DEP13903

# LAUREL RUN MINE SHAFT PROJECT (CRELLIN BORE HOLE PROJECT) DEP13903

#### **ADDENDUM #1**

FIG. 7

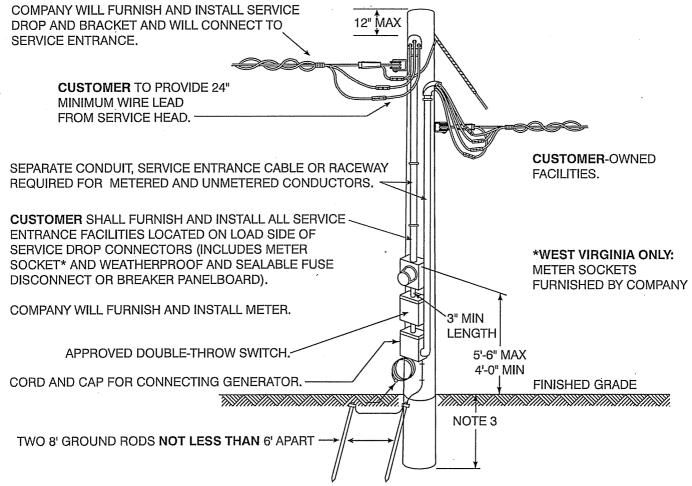
The contractor shall provide all customer required facilities in accordance with the attached Figure 7 and as per <u>Customer Requirements for Electric Service</u>, effective April 1, 2005. The contractor shall provide the required service entrance facilities (service pole and appurtenances) with disconnect or breaker panel board for single phase 200 AMP service for connection to the service drop from Allegheny Power. The electrical connection will be completed in the next contract for the doser and building.
